IEEE P802.15
Wireless Personal Area Networks

Project	IEEE P802.15 Working Group for Wireless Personal Area Networks (WPANs)	
Title	TG3 LB12 St. Louis comment resolution	
Date Submitted	[8 July, 2002]	
Source	[James P. K. Gilb] [Apparent Technologies] [9921 Carmel Mountain Rd. #247, San Diego, CA 92129]	Voice: [858-538-3903] Fax: [858-538-3903] E-mail: [gilb@ieee.org]
Re:	[]	
Abstract	[This document is a record of comment resolutions for LB17.]	
Purpose	[To provide a record of the comment resolution for LB17.]	
Notice	This document has been prepared to assist the IEEE P802.15. It is offered as a basis for discussion and is not binding on the contributing individual(s) or organization(s). The material in this document is subject to change in form and content after further study. The contributor(s) reserve(s) the right to add, amend or withdraw material contained herein.	
Release	The contributor acknowledges and accepts that this contribution becomes the property of IEEE and may be made publicly available by P802.15.

1. Comment resolution, Vancouver to Schaumburg

Figure 1—MSC for a approved asynchronous channel time request

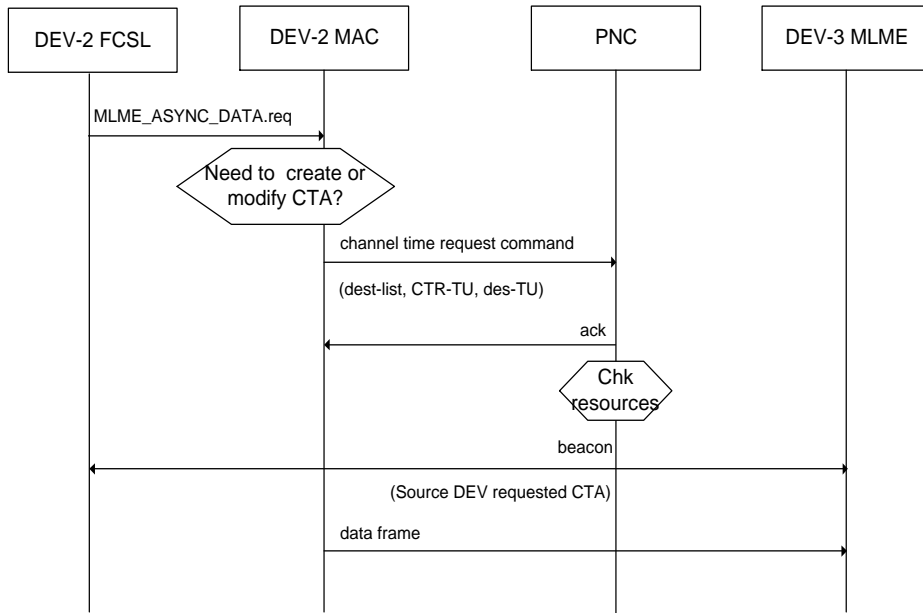
Figure 119 – MSC for reserving asynchronous data channel time. Discussed earlier, new MSC is below:
